Current Zoning: R-17MF (multi-family residential)  
Proposed Zoning: MUDD-O, 5-year vested rights (Mixed use development, optional, 5-year vested rights)

Approximately 9.13 acres bound by the north side of Roxborough Road, west side of Colony Road, and east side of Rexford Road, south of Wickersham Road.

The petition proposes to redevelop a group of condominiums with a mixed-use development including non-office commercial uses, eating/drinking/entertainment establishments, and residential uses located at the edge of South Park just south of the Barclay Downs neighborhood.

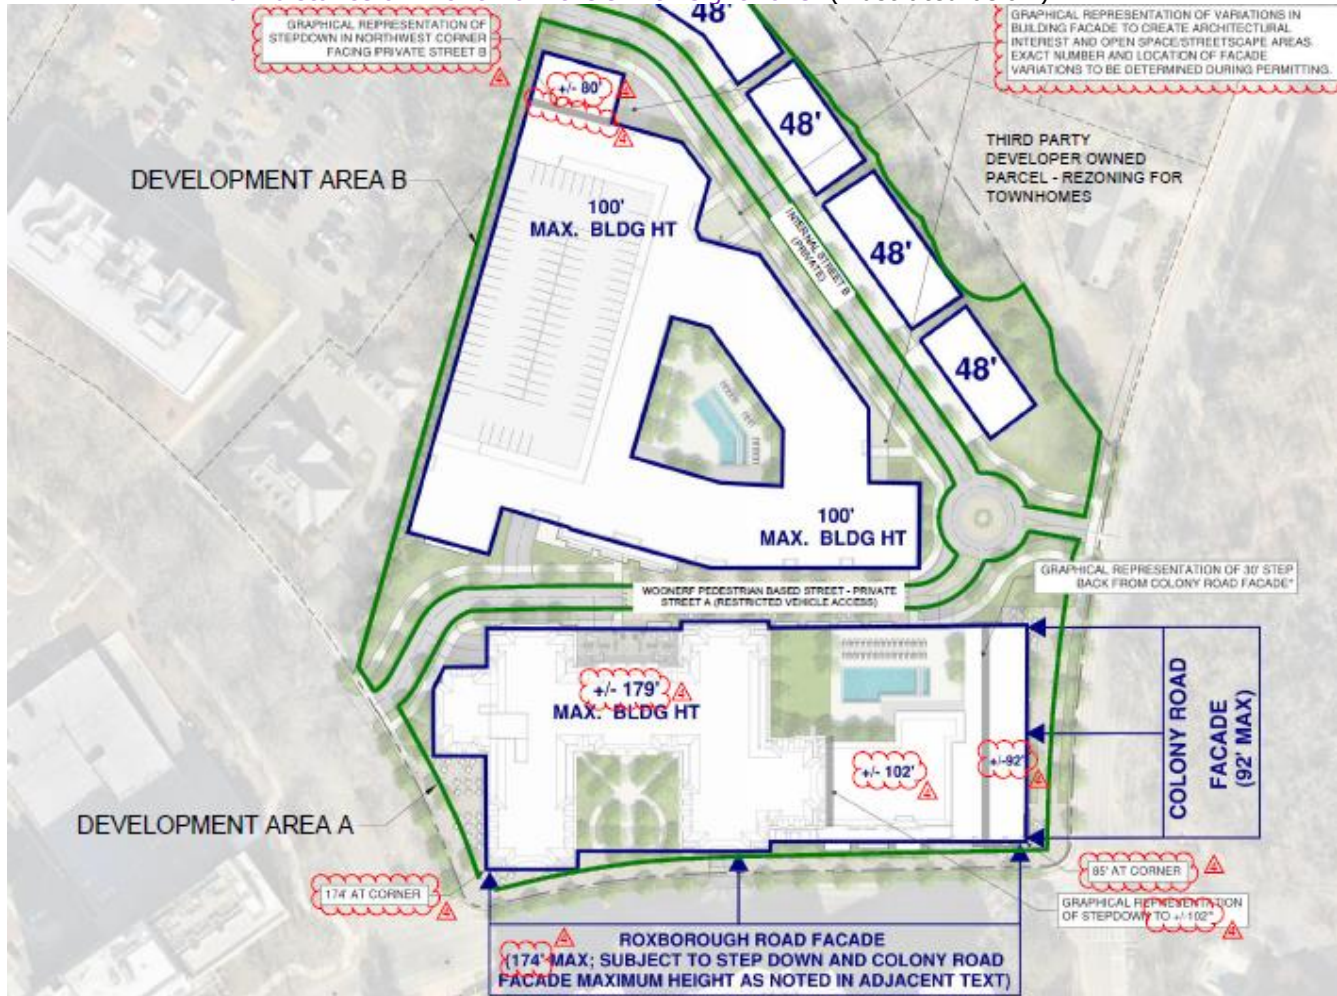
- Building heights:
  - Area A – Maximum of ~~169 ft~~ [179 ft](#) with a maximum of ~~164 ft~~ [174 ft](#) at the corner of Rexford and Roxborough Rd. with step down as the development approaches Colony Rd.

Maximum height of 92 ft for a minimum distance of 30 ft from building face along Colony Rd. (a maximum of 85 ft at the corner of Roxborough and Colony). A maximum height of 102 ft for a minimum distance of 120 ft from the 92 ft height zone. (illustrated below)

- Area B – Maximum of ~~119~~ 100 ft with a maximum of ~~60~~ 80 ft at the northwest corner of the building (illustrated above).
  - Area C – Maximum of 48 ft
